Proposed Modification to the CRU/DRU Allocation in the PHY Structure (Section 15.3.5.3.1 and 15.3.8.3.1)

C802.16m-09/2529

Re: P802.16m/D2 comments for LB30a

Area: Section 15.3.5.3.1 – DL PHY Structure and Section 15.3.8.3.1 – UL PHY Structure.

Case 1: DSAC=10, DCAS_{SB,0} = 9

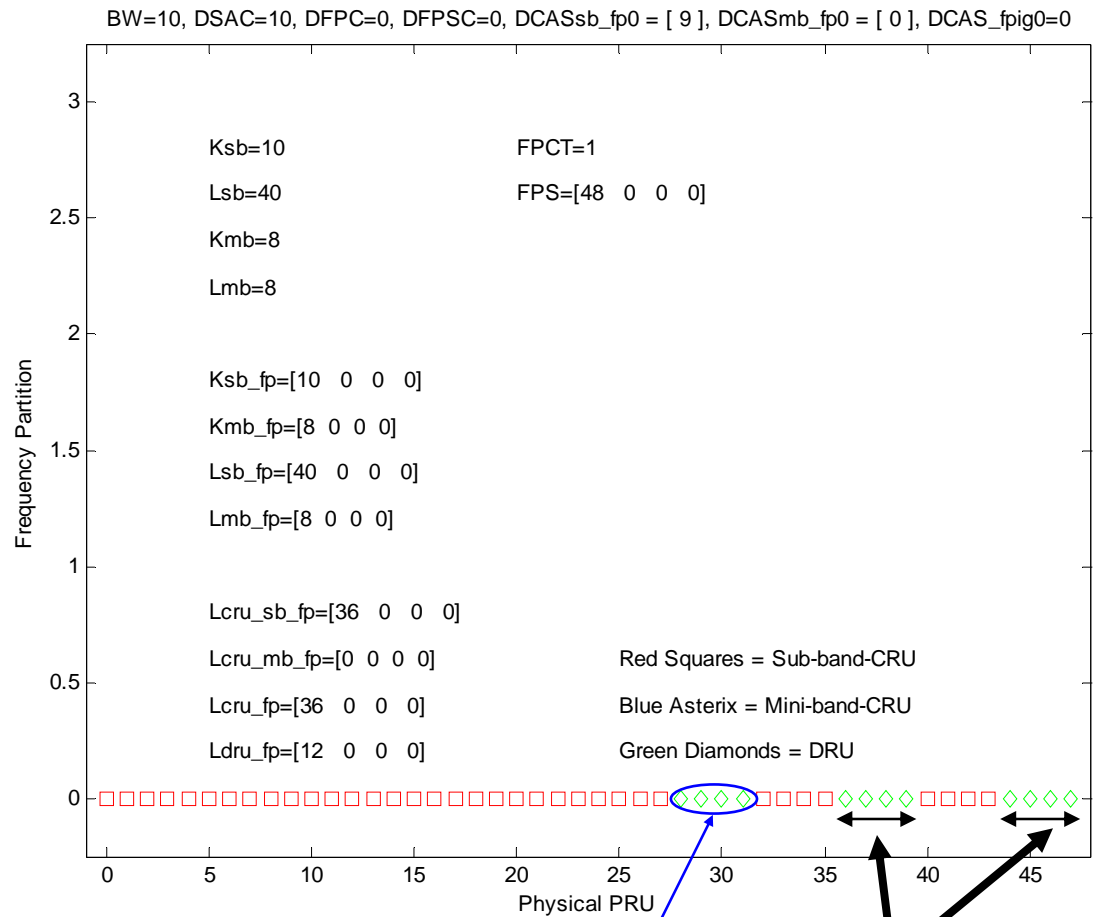
- Consider the max SLRU configuration, but set the DCAS_{SB,0} variable differently:
- If DSAC=10, but DCAS_{SB,0} is 9:
 - Some DLRUs exist in PRUs that are sub-bands.
 - Not a problem

**DLRUs existing
inside sub-band
PRUs**

- [*Section 15.3.5.3.1, Page 297 (Downlink) : Insert this sentence after the first sentence of the paragraph that starts on line 12:]
DCAS_{SB,0} shall be \leq Ksb.*
- [*Section 15.3.8.3.1, Page 454 (Uplink) : Insert this sentence after the first sentence of the paragraph that starts on line 12:]
UCAS_{SB,0} shall be \leq Ksb.*

Case 2: DSAC=10, DCAS_{SB,0} = 11

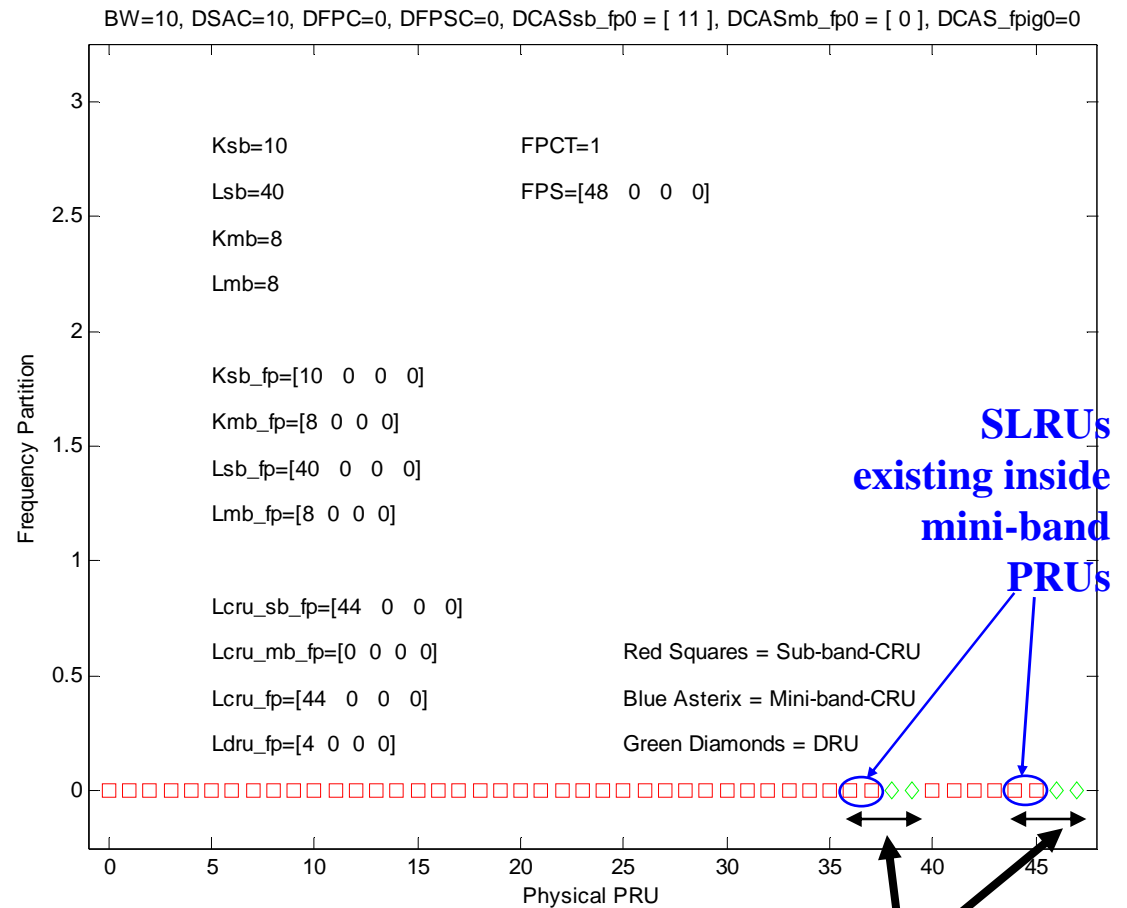
- Consider the previous example where the PHY is configured for maximum SLRUs, but where the $DCAS_{SB,0}$ variable set differently:
- Case 1: If $DSAC=10$, but $DCAS_{SB,0}$ is 9:
 - Some DRUs exist in PRUs that are sub-bands
 - Not a problem
- Case 2: If $DSAC=10$, but $DCAS_{SB,0}$ is 11:
 - Some Sub-band CRUs exist in PRUs that are mini-bands!
 - This flexibility is not necessary and may create difficulties for sub-band selection
- We propose limiting $DCAS_{SB,0}$ to be no greater than K_{sb}

- Consider the max SLRU configuration, but set the DCASsb0 variable differently:
- If DSAC=10, but DCAS_{SB,0} is 11:
 - Some Sub-band CRUs exist in PRUs that are mini-bands!
